Current Zoning: UMUD-O (uptown mixed use development, optional)  
Proposed Zoning: UMUD-O SPA (uptown mixed use development, optional, site plan amendment)

The petition proposes a site plan amendment to approved rezoning petition, 2021-163. This rezoning would amend the existing conditional plan to add an additional vehicular access point and pedestrian connectivity.

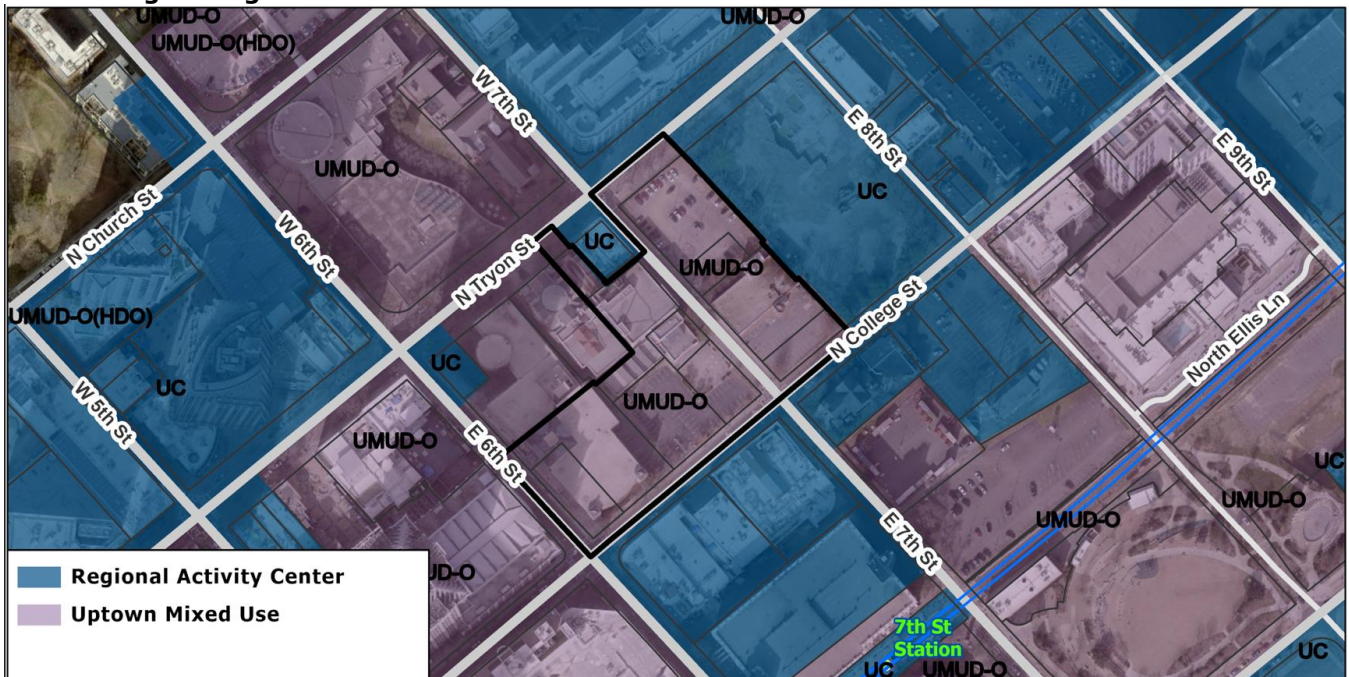
- Provides an additional full movement vehicular access point to Building Envelope B off East 7<sup>th</sup> Street.
- Commits to additional pedestrian connectivity by dividing what was previously Building Envelope A into Building Envelopes A and A1, with a pedestrian connectivity path between the building envelopes that runs from North Tryon Street to North College Street while maintaining the other pedestrian connectivity to East 6<sup>th</sup> Street.

- Adds a commitment to an 8’ minimum pedestrian clear zone shall along East 7<sup>th</sup> Street.
- Maintains uses as approved in petition 2021-163 for all uses permitted by-right and under prescribed conditions in the UMUD district.

- Proposes retractable bollards inside the East 6<sup>th</sup> Street service vehicle only entrance.
- Proposes retractable bollards inside the North College Street service vehicle only entrance.

- Commits to maintain the use of bollards and planters along East 7<sup>th</sup> Street for pedestrian safety.
- Maintains previously approved optional provisions from petition 2021-163 as follows:
